RE: TEDS Exception No. 05-03, to Reduce Access Spacing at 2710 Patterson

### **DESIGN EXCEPTION #DE05-03**

To: Mark Relph, Director of Public Works & Utilities  
Thru: Tim Moore, Public Works Manager  
Copy to: Rick Dorris, Development Engineer  
Pat Cecil, Development Services Supervisor  
From: Mike McDill, City Engineer  
Date: February 25, 2003  
RE: Request to Reduce Access Spacing at 2710 Patterson

(DRAWING #1 - CURRENT LAYOUT)

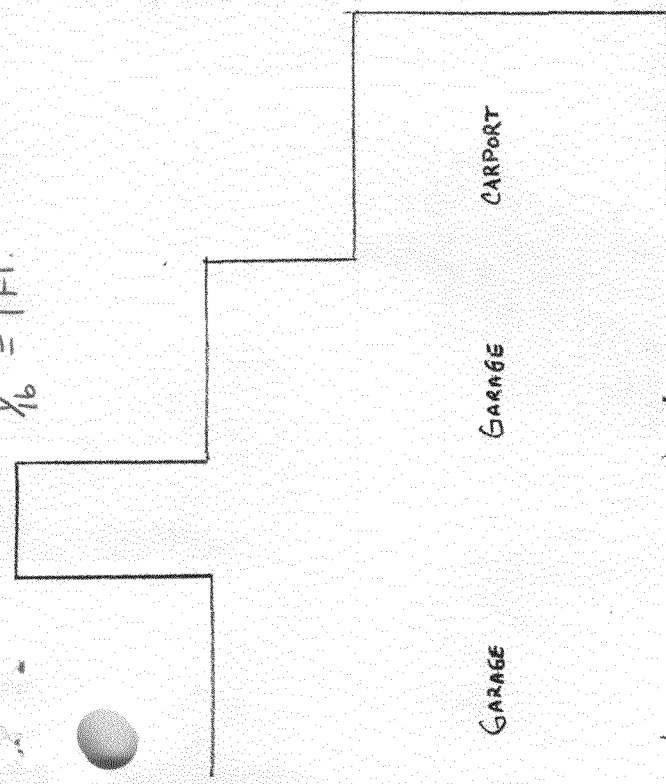
Allowing ingress/egress access point to be approximately 130ft from the nearest Western access point and approximately 95ft from the nearest Eastern commercial access point which would be an egress point. There are currently 2 access points on my property (ref. diagram 1). My property is 103ft in width. There is no way to physically to place an ingress/egress on my property without a TEDS exception because the access points for the properties on both sides make it impossible to locate my ingress/egress 150ft from neighboring access points.

DRAWING 2 - PROPOSED LAYOUT  
1/16" = 1 FT.

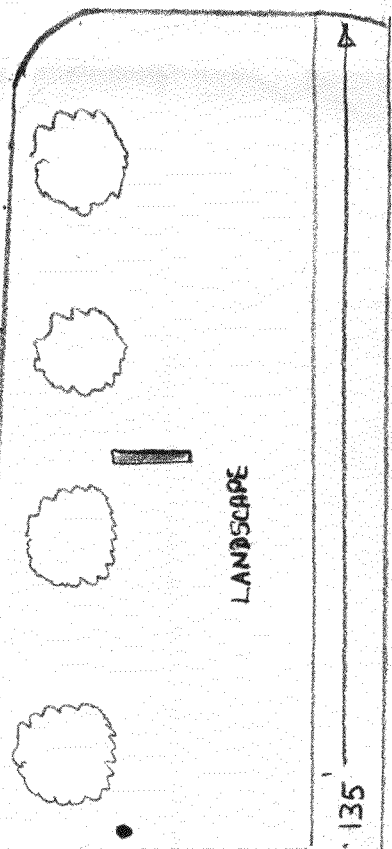
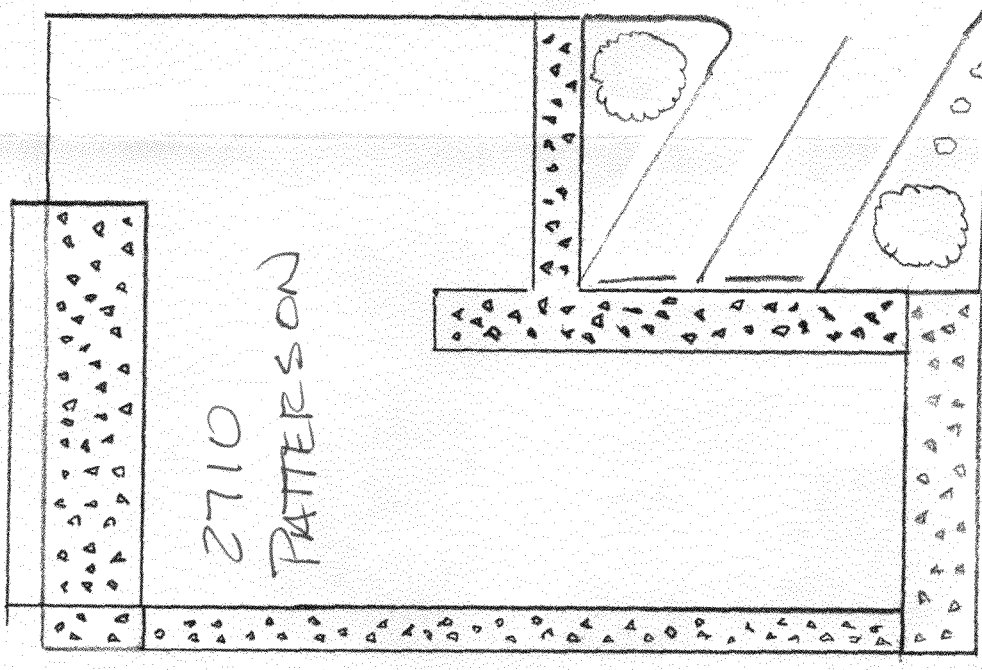
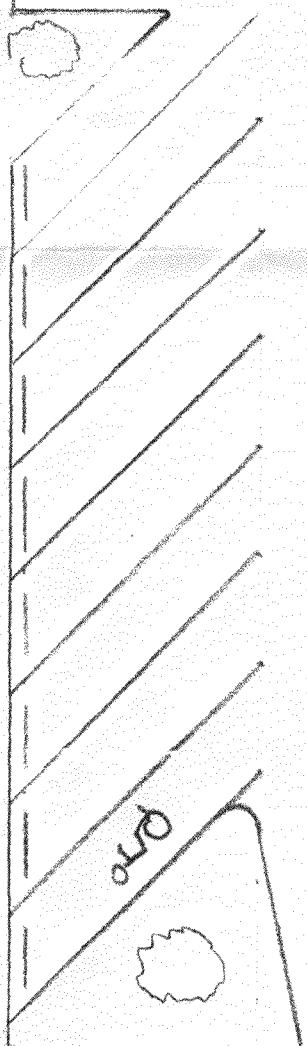
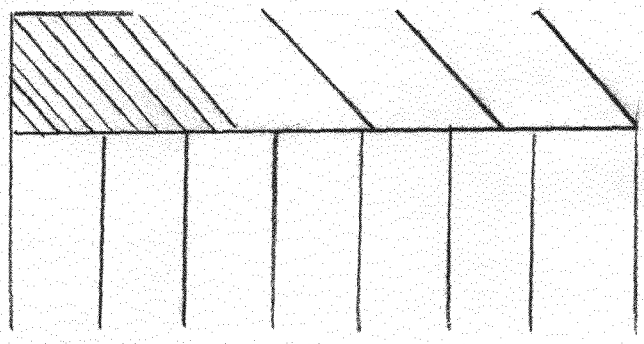
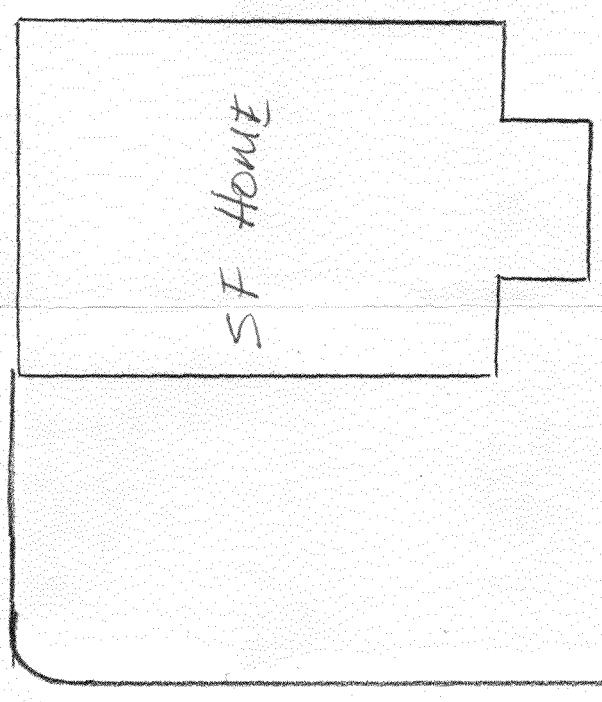
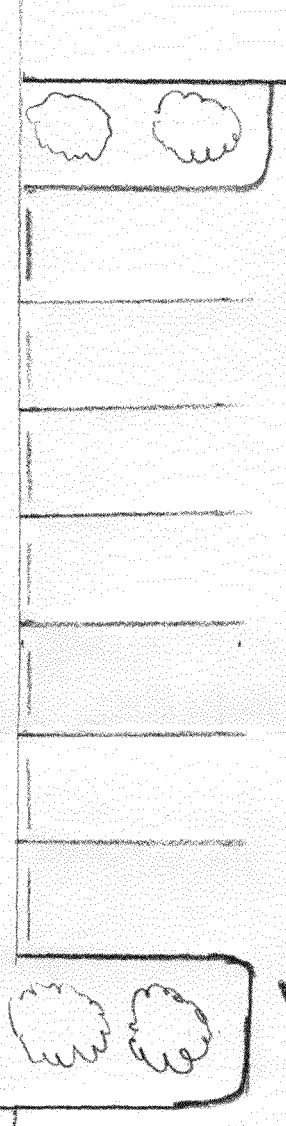
This plan will immediately eliminate one access point along Patterson Road. It would also lead to the future elimination of the direct accesses to the Counseling Center and the property to the east if the joint access agreement was worded broadly enough. **This developer should be required to execute a joint access agreement for any neighboring properties that can potentially use this access point.** No significant safety issue exists at the new location because it will eventually be the only one in the vicinity and future opposing accesses will be separated by a median.

To construct ingress/egress point at far East side of my property with a divider to keep traffic flowing to the rear of my building for parking and one way continuous traffic flow. Parking would be angeled to allow for easy access and one way traffic flow in and out of parking area to flow smoothly. I will be willing to give up one of my access points (on the West side). I also propose to sign an agreement with the City that the property to the East shall be allowed access and useage of this ingress/egress access point if this property should ever have a change of use. This would require that property to close its

access point which would be eliminating one more access point on Patterson Rd. That property is also zoned RO and is currently being used as a residence. (Ref. to drawing 2 for proposed plan). If TEDS exception is approved this layout will be engineered to meet all other standards concerning parking, drainage and landscape.

I recommend approval of the requested Design Exceptions to Section 4.1.1 to allow the new parking lot access from Patterson Road, as long as it is designed to meet all other requirements of the TEDS and a properly worded joint access agreement is signed and delivered. In the future reference may be made to this exception when the adjoining properties re-develop.
